MINUTES
BOARD OF BUILDING STANDARDS/
ARCHITECTURAL BOARD OF REVIEW/SIGN REVIEW
MAY 12, 2016
5:30 P.M.
LAKEWOOD CITY HALL
COUNCIL CONFERENCE ROOM

**C 14601 Detroit Avenue and 1422 Belle Avenue
Lakewood Family Health Center**

Lakewood Family Health Center

RESPONSES TO ABR

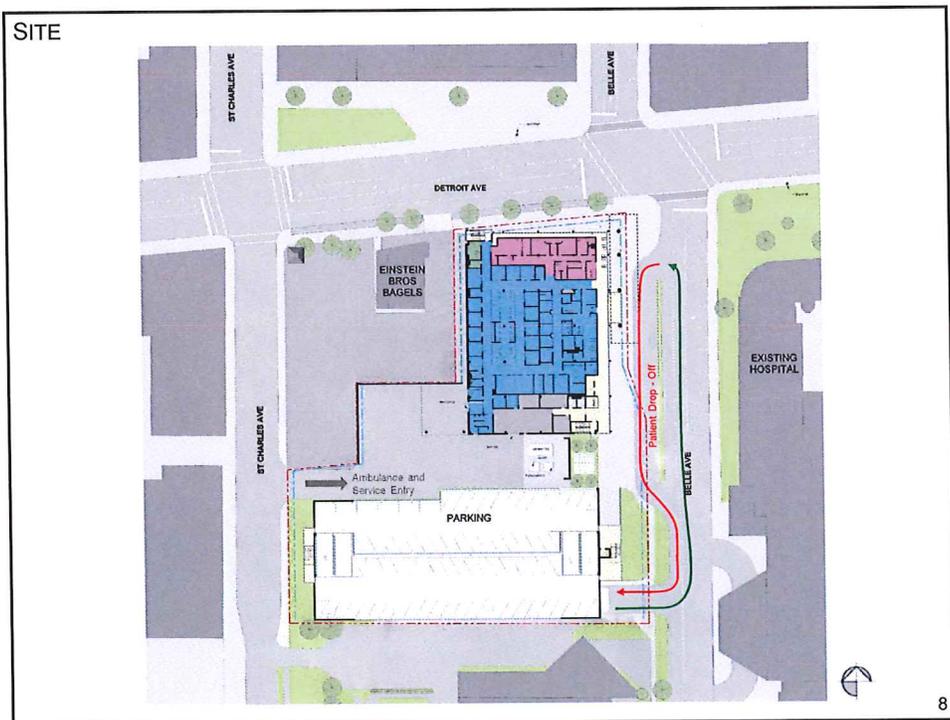
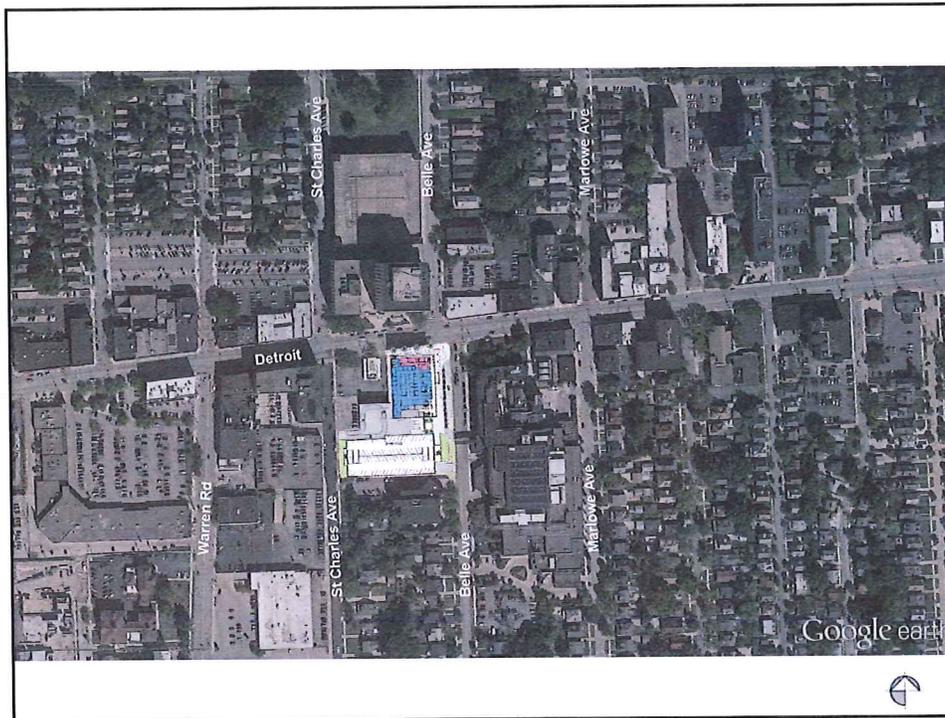
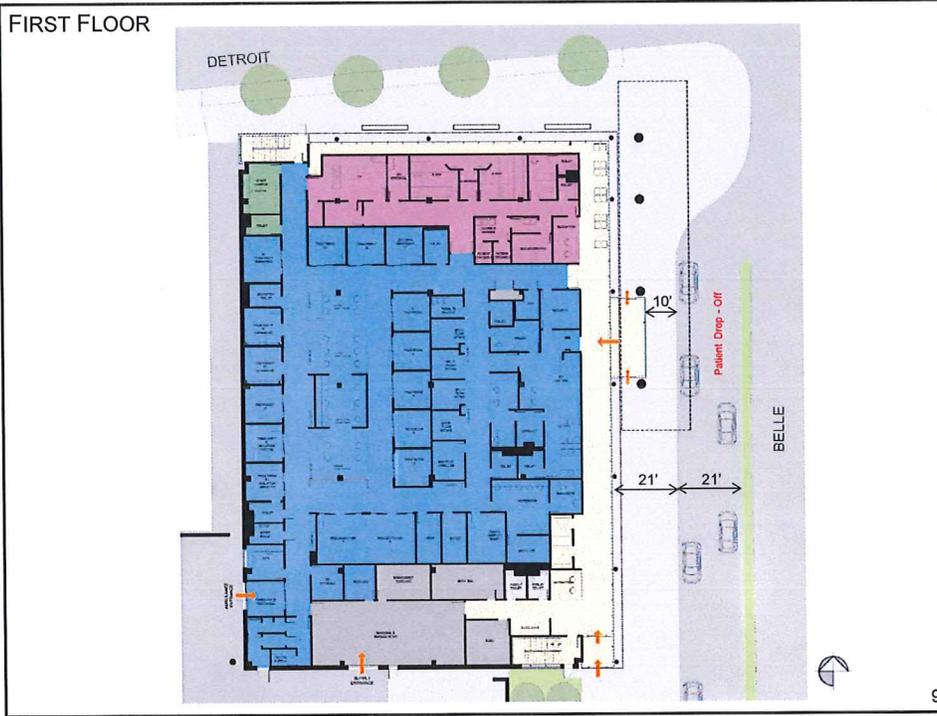
- Staircase looks even more disengaged from the building.
- Staircase looks like a service stair case. Can it be pulled back into the building?
 - **Moved north stair inside the building.**
- What are the spacing and dimensions for the drop off area?
- How does vehicular traffic access the drop-off? May want to look at circulation issues.
 - **Delineated a turning lane northbound on Belle.**
- There are no back elevations on this building. They are all primary elevations. Four sided design.
 - **Developed all 4 sides of the building.**

- Bring the building edge to the street. Hold the urban edge. Board does not want to repeat the ills of the past. (ex. YMCA)
 - **Moved the Family Health Center to the north property line.**
- How do pedestrians traveling on Belle who are not accessing the FHC navigate the site? Doesn't feel like a public sidewalk through that area.
 - **Provided wider sidewalk east of entry vestibule.**
- How do you activate Detroit?
 - **Added gallery to north side of the building.**

RESPONSES TO ABR

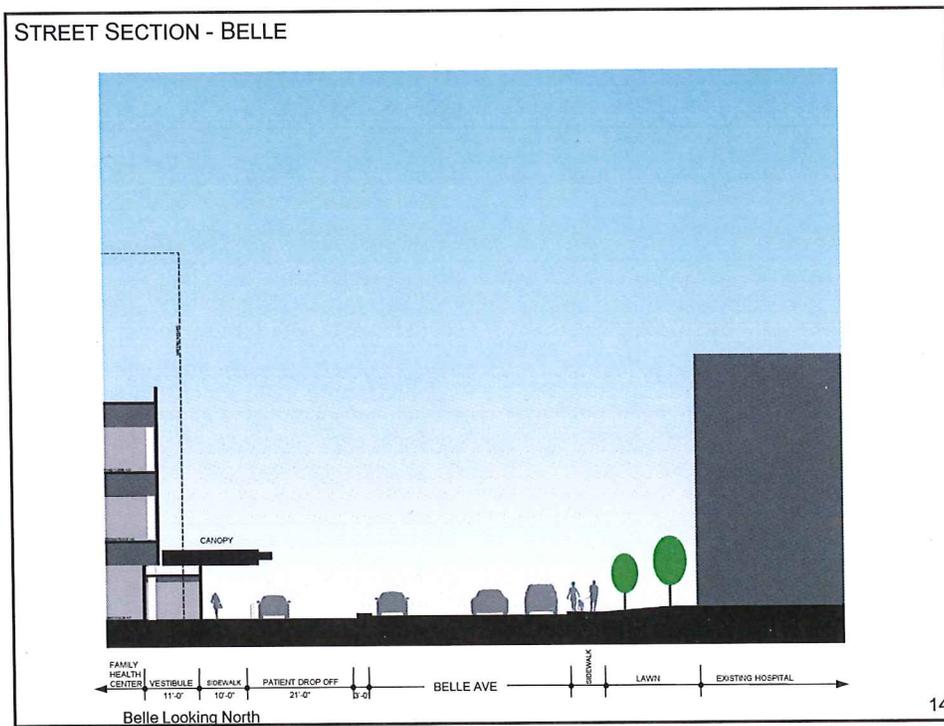
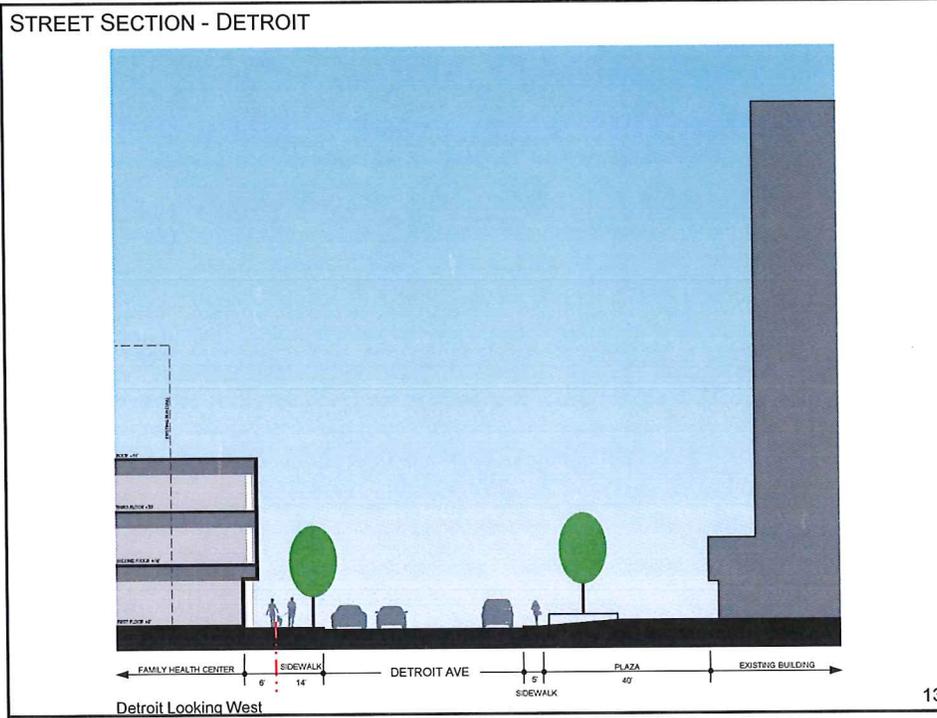
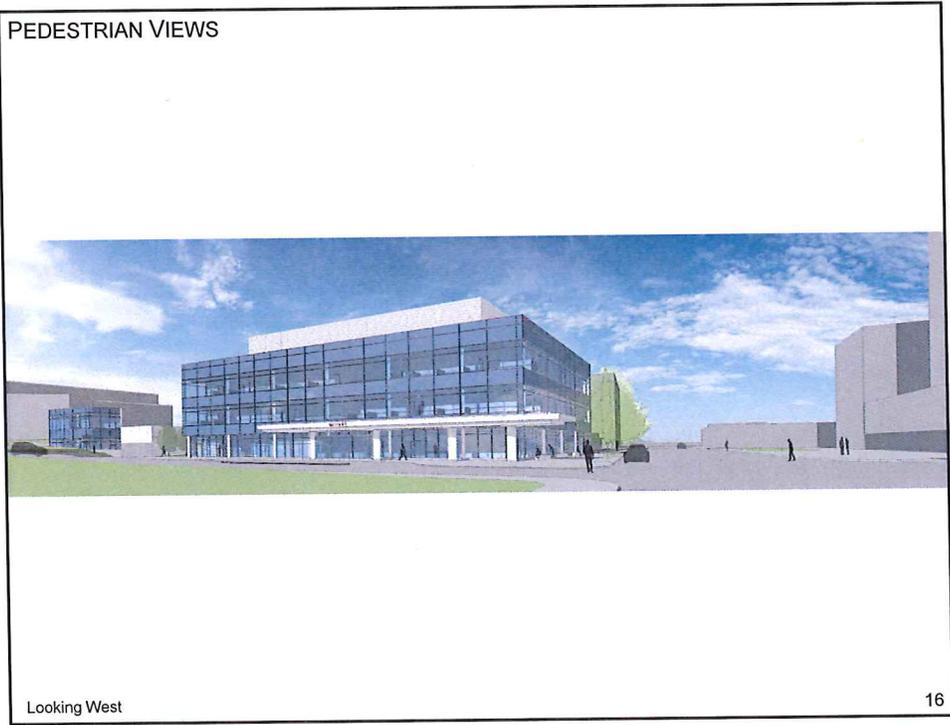
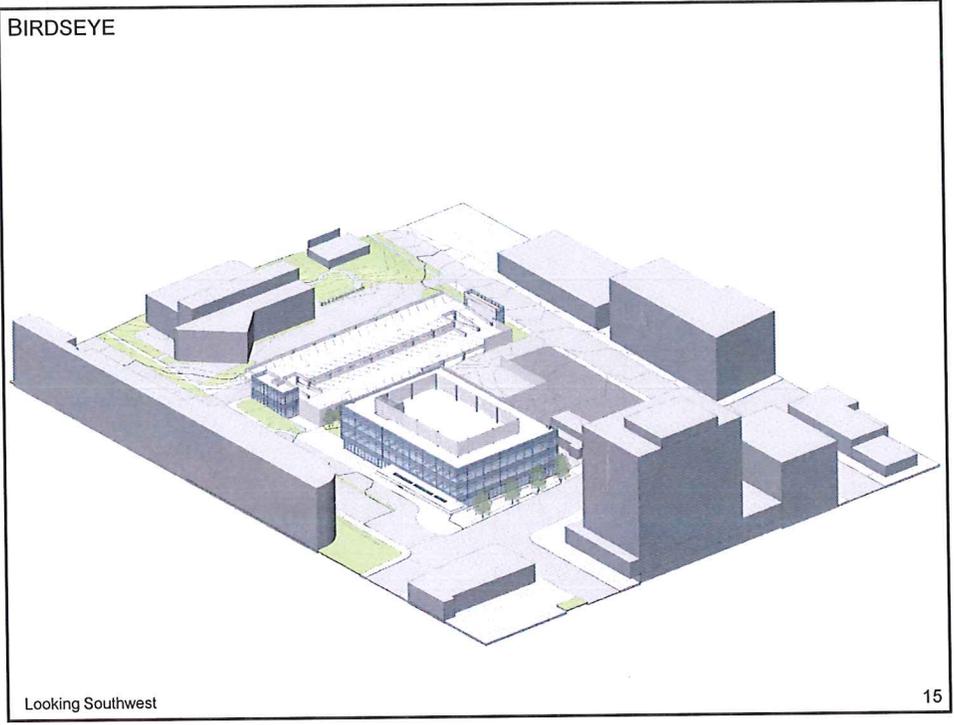
- Wrap canopy around to Detroit to help incorporate staircase so it looks less like a utility stair on our commercial corridor.
 - **Eliminated external stair allowing extended Canopy to be more visible and engaging.**
- Can there be transparency and gallery on the third floor as well?
 - **Transparency in exterior with attention to ceiling surfaces and lighting to relate to gallery spaces below.**
- Redundant pedestrian circulation between patient parking garage and FHC entrance.
 - **Deleted the pedestrian link between the garage and Family Health Center.**

16615 Delaware

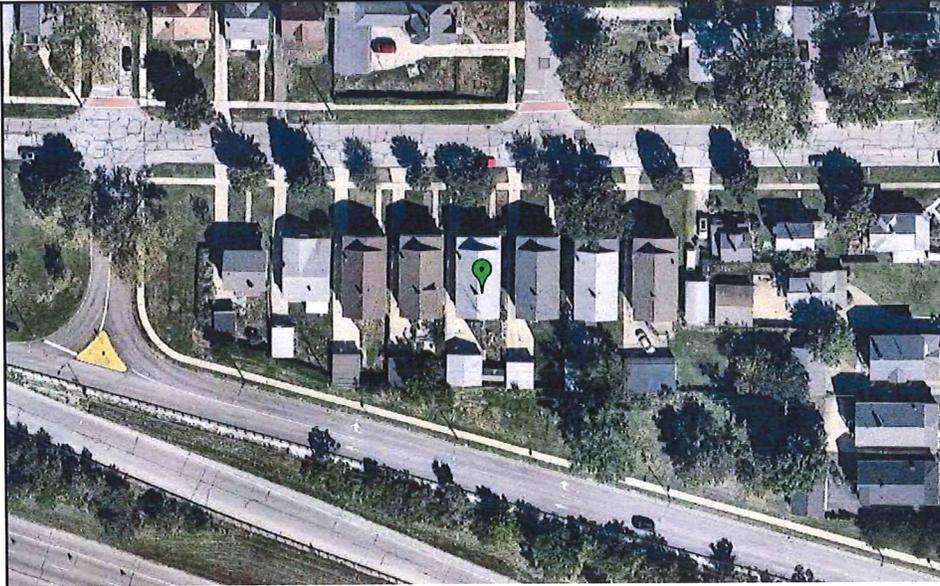
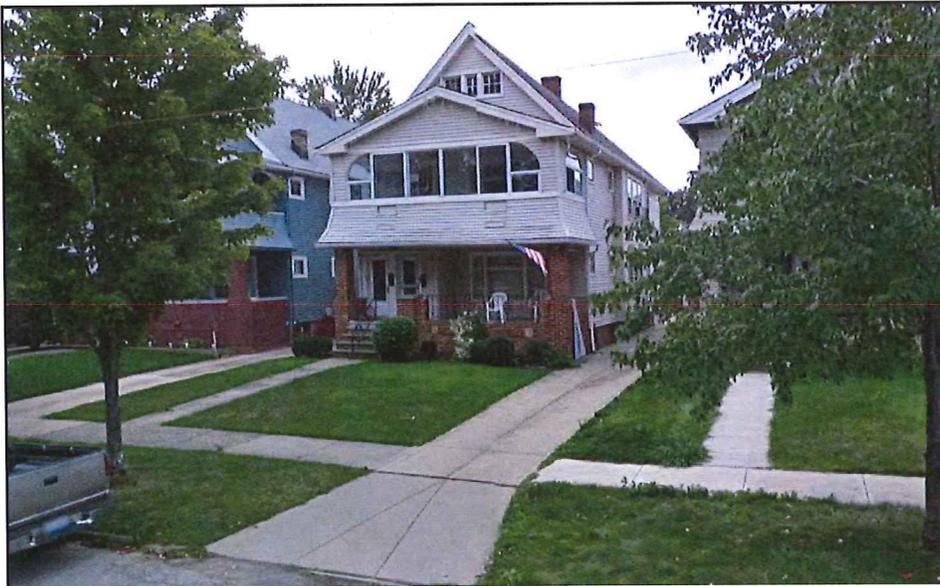
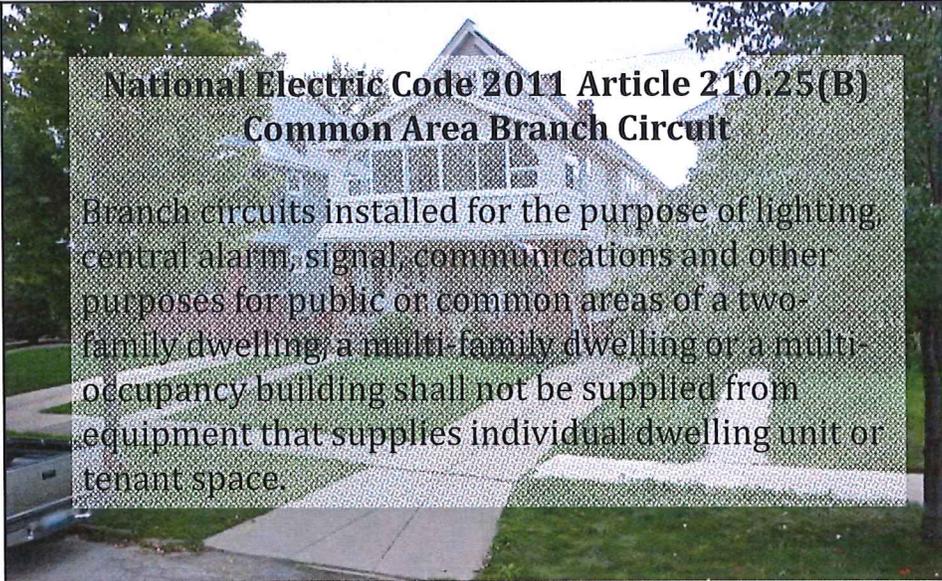
The applicants request the review and approval of a variance to the Ohio building Code; the applicants do not want to add a third electrical panel. (Page 14)

Mr. Robar said the granting of a variance would be going against the Ohio Building Code. The board inquired if the home could be converted to a single family home. Mr. Robar wanted to defer in order to get questions answered prior rendering a decision.

A motion was made by Mr. Robar, seconded by Mr. Evans to **DEFER** the request **until the meeting of June 9, 2016**. All of the members voting yea, the motion passed.

14200 Detroit

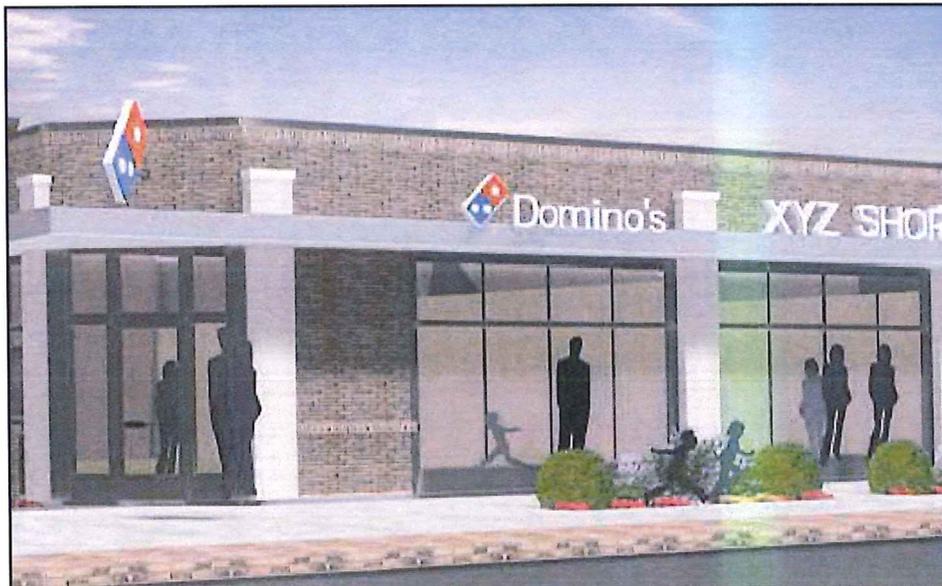
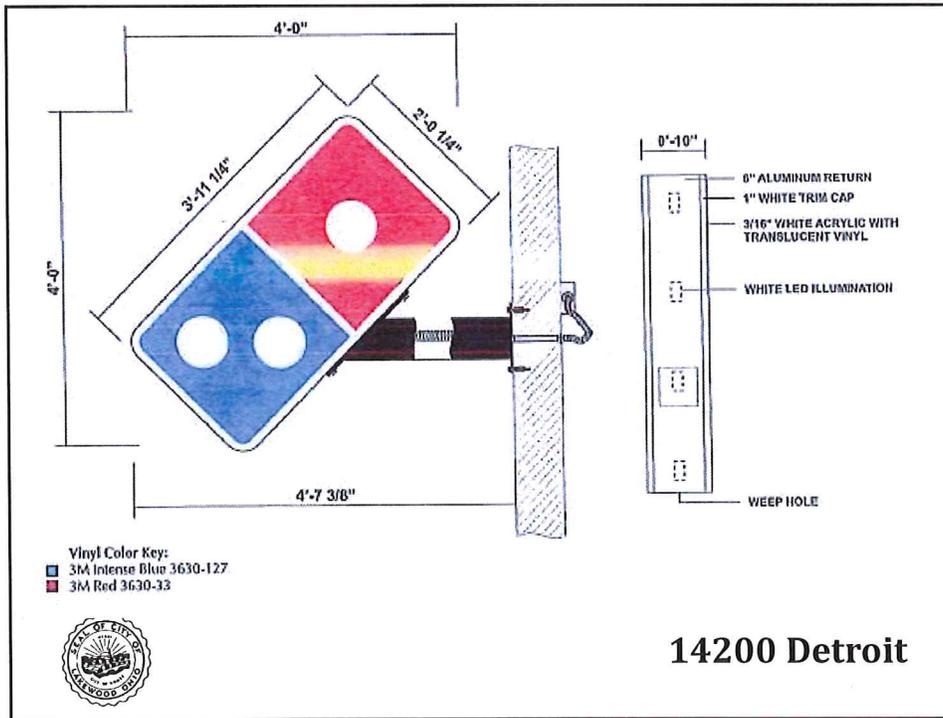
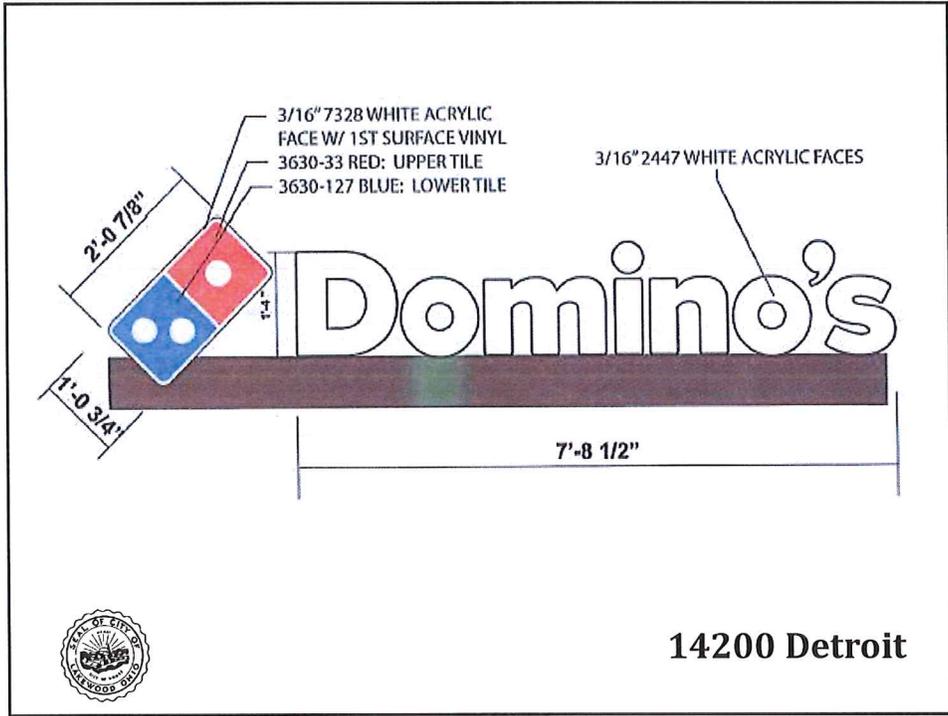
The board thought the “domino” would look better mounted on the canopy, and the letters illuminated. The board asked Mr. Margulies to explain the particulars regarding the comprehensive sign package.

A motion was made by Mr. Robar, seconded by Mr. Evans to **APPROVE** the request with the following stipulations:

- **the depth was five inches (5”), and**
- **there would be no overhang of the sign and to remain flush.**
